APPEAL SUMMARY

Appeal ID: 21957	Project Address: 230 SW Ash St	
Hearing Date: 10/2/19	Appellant Name: Tom Jaleski	
Case No.: B-017	Appellant Phone: 9712385266	
Appeal Type: Building	Plans Examiner/Inspector: Geoffrey Harker	
Project Type: commercial	Stories: 6 Occupancy: R-2, S-2, M, B Construction Type: I-A, III-B	
Building/Business Name:	Fire Sprinklers: Yes - throughout	
Appeal Involves: Erection of a new structure	LUR or Permit Application No.: 17-208579-CO	
Plan Submitted Option: pdf [File 1]	Proposed use: Residential, parking, retail

Appeal item 1

PROJECT 3RD & ASH

SHEET TITLE ENLARGED FLOOR PLANS - LEVEL 1

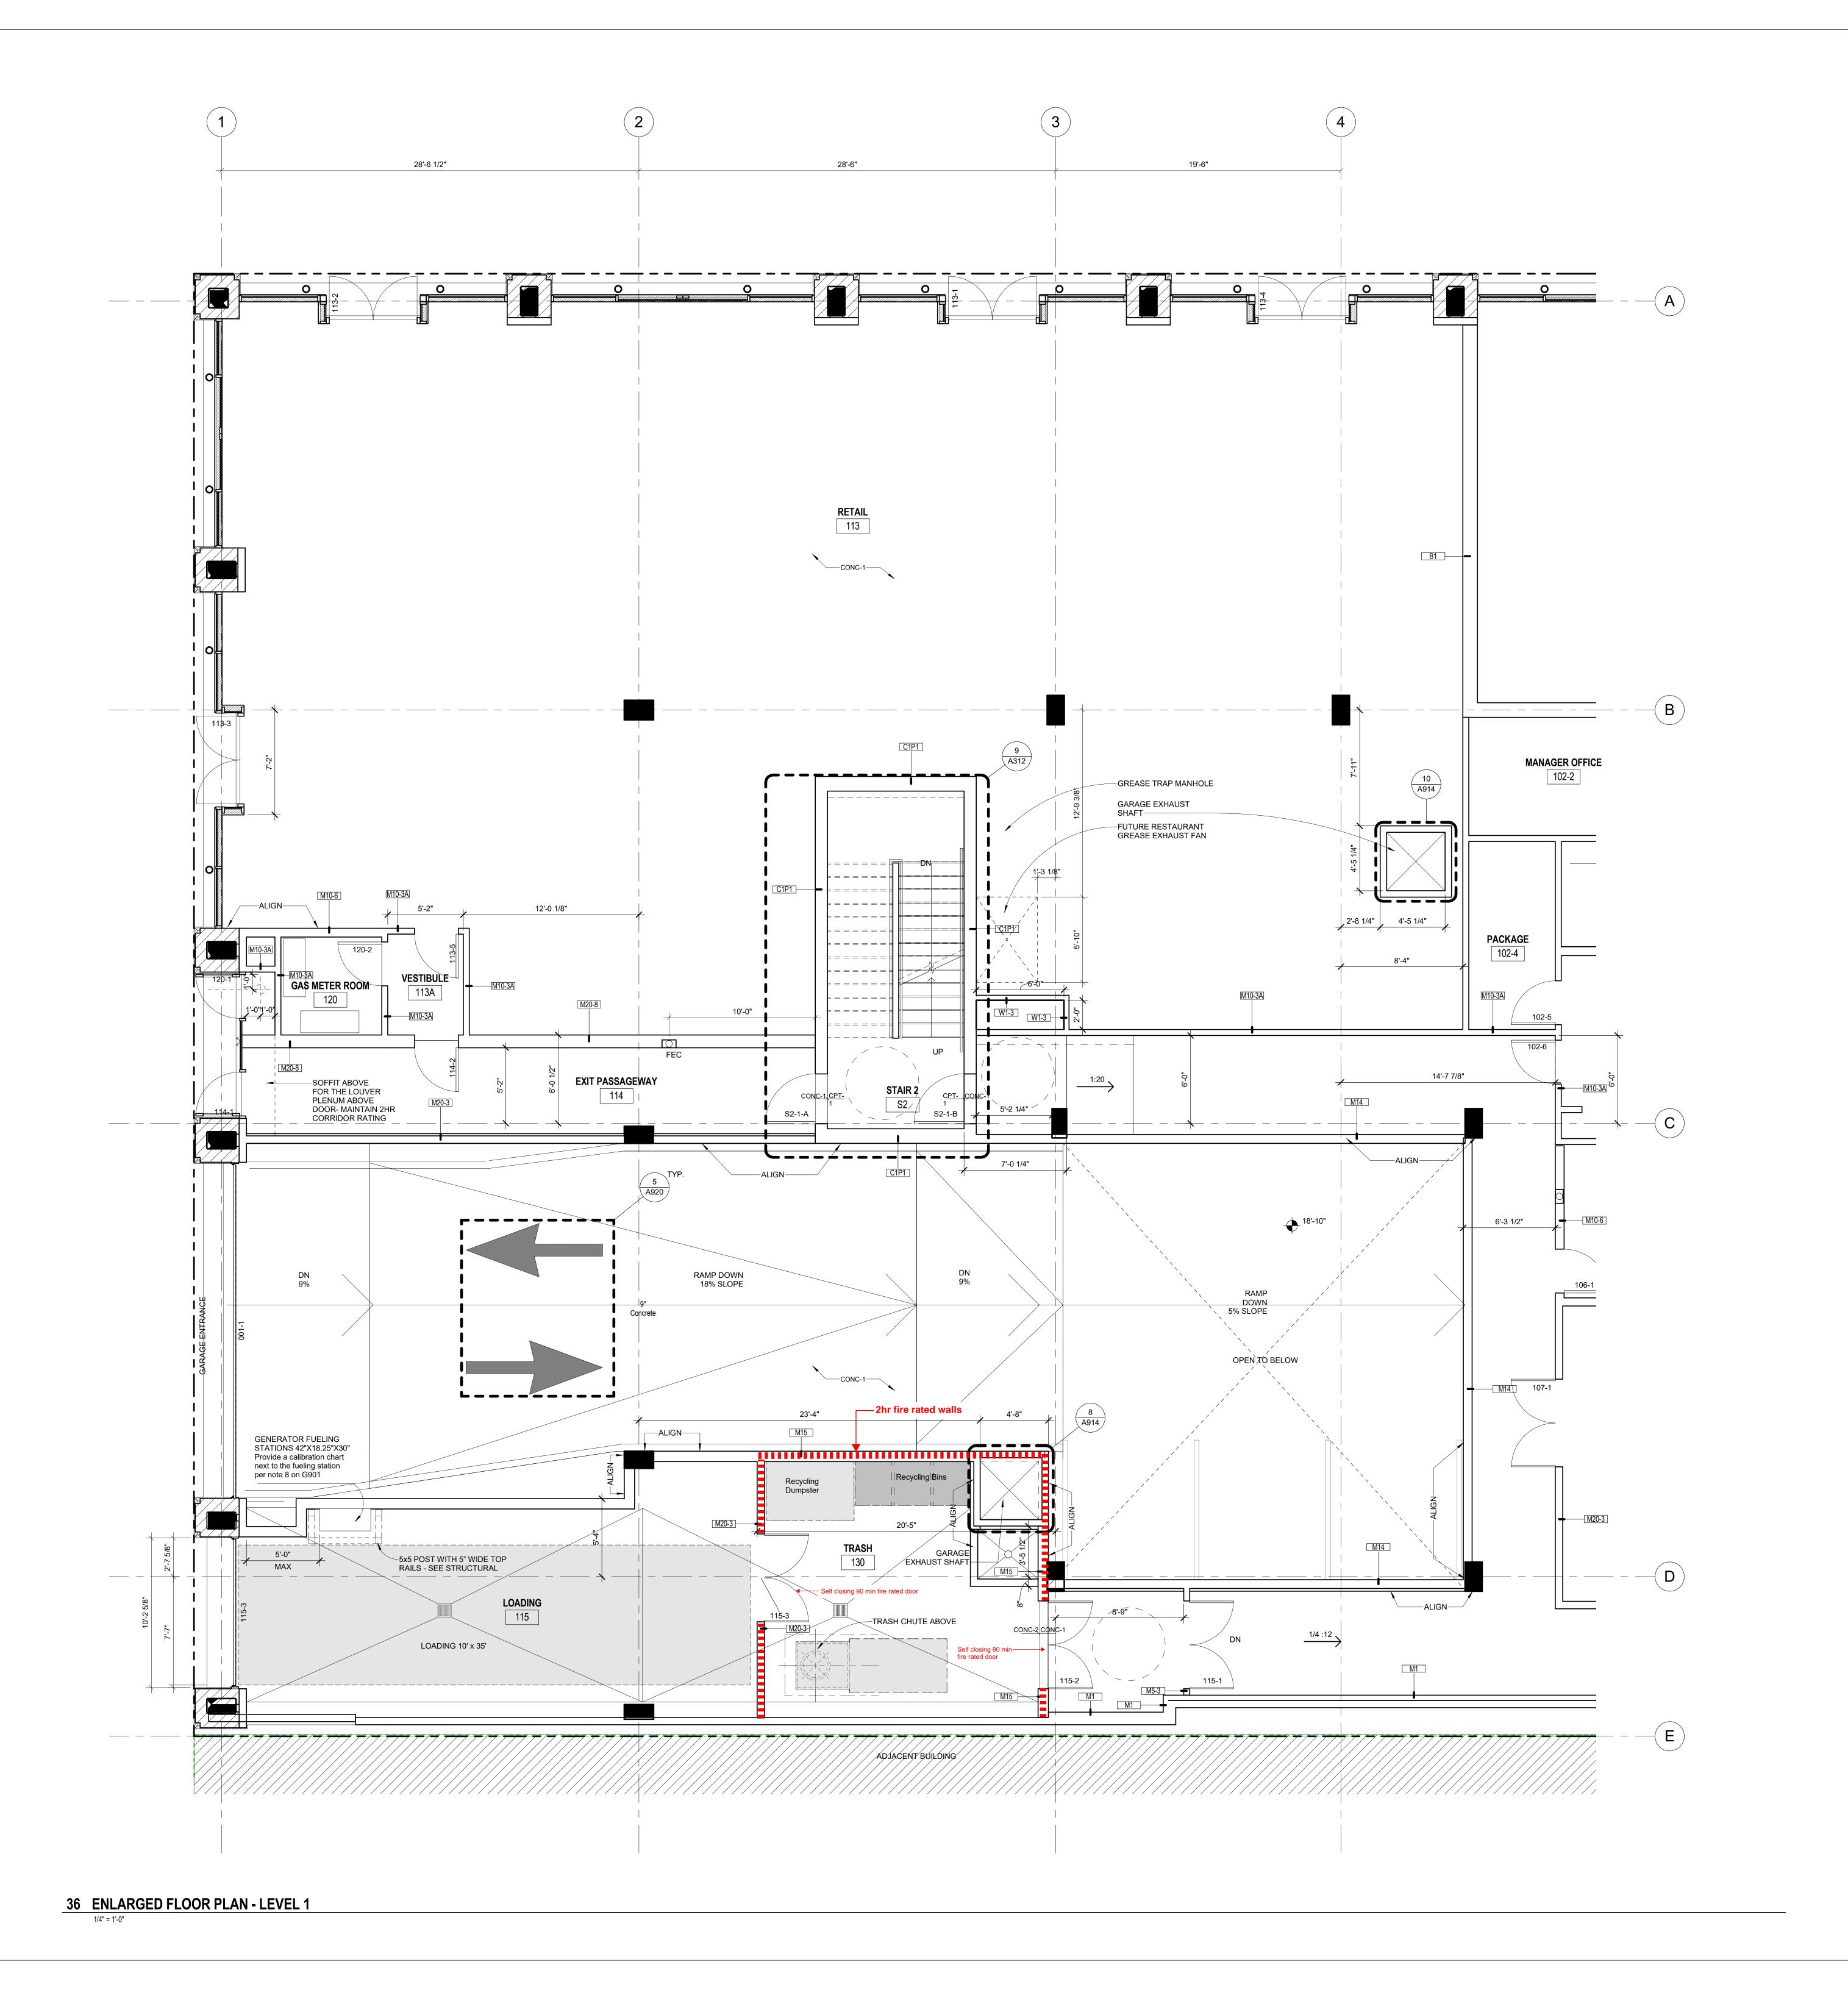
The proposed design is to meet all the requirements of Oregon's 2019 Structural Specialty Code (OSSC) 713.13 for the waste chute termination room. The attachment shows the plan for the termination room, diagrammatic section, and photo of existing condition. The following protection measures will be provided to the termination room as required by 2019 OSSC:

- --Building sprinklered with an NFPA13 system throughout.
- --2 hour rated fire barrier walls around trash room and any other part of the building.
- --90 minute rated doors with automatic closers activated by smoke detectors in the termination room.
- --Opening penetration protections per Section 716.

The termination room will have the same fire-resistance rating as the shaft with fire-resistance rated doors that are auto-closing activated by smoke detectors in the termination room. All other openings will be protected as required per Section 714. The shaft enclosure, materials and access room will meet all the requirements of 2019 OSSC section 713.13.

Shaft opening in termination room: Denied. Proposal does not provide equivalent Life Safety protection. Appellant may contact John Butler (503 823-7339) with questions.
